# Access Compliance Report

## Public Rights-of-Way

Intersection ID: 3786	Main Street: GALLOWAY_RD	Cross Street: MALLARD_CREEK_RD	Location:	N
ADA ID: 40E7B9A43015	Ramp Type: Perp	Initial Pass/Fail: Fail	Overall Compliance: No	Severity Score: 8.75
Codes/Mitigation Info/Possible Solution		Field Measurements/Component Compliance

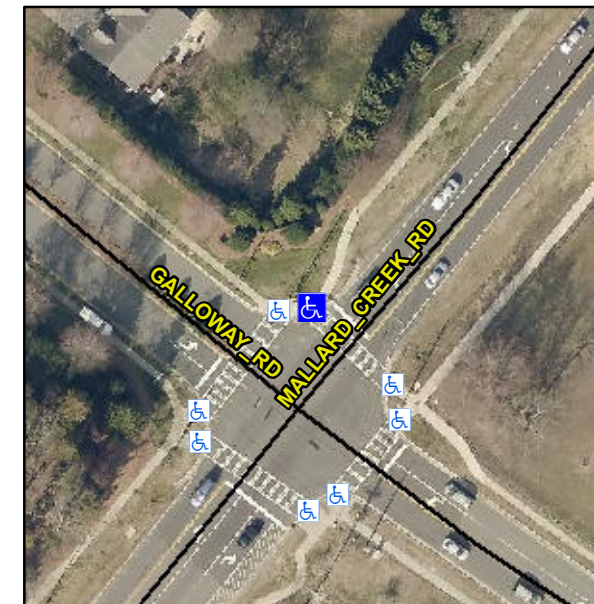
**Remove & Replace Entire Ramp.**

**R304.5.1**

Compliance	Description	Data	Compliance	Description	Data
N/A	Ramp Length (in)	71.0	Yes	Ramp Slope (%)	8.1
No	Ramp Width (in)	46.0	Yes	Ramp XSlope (%)	0.3
N/A	Flare Type LT	N/A	N/A	Flare Type RT	N/A
N/A	Flare Slope LT (%)	N/A	N/A	Flare Slope RT (%)	N/A
N/A	Flare Traversable LT?	N/A	N/A	Flare Traversable RT?	N/A
N/A	Landing Length (in)	N/A	N/A	DWS Provided?	N/A
N/A	Landing Width (in)	N/A	N/A	DWS Contrast?	N/A
N/A	Landing Slope (%)	N/A	N/A	DWS Length (in)	N/A
N/A	Landing X Slope (%)	N/A	N/A	DWS Full Width?	N/A
N/A	Landing Curb? (Y/N)	N/A	N/A	DWS Offset (in)	N/A
N/A	Shared Landing?	N/A			
N/A	Gutter Ponding?	N/A	N/A	Gutter Slope (%)	N/A
N/A	Gutter Lip Ht (in)	N/A	N/A	Gutter X Slope (%)	N/A
N/A	Painted X Walk1?	Yes	N/A	Painted X Walk2?	N/A
	X Walk 1 Direction	To SE		X Walk 2 Direction	N/A
N/A	X Walk 1 Width (in)	109.0	N/A	X Walk 2 Width (in)	N/A
	X Walk 1 Slope (%)	3.8		X Walk 2 Slope (%)	N/A
	X Walk 1 X Slope (%)	1.2		X Walk 2 X Slope (%)	N/A
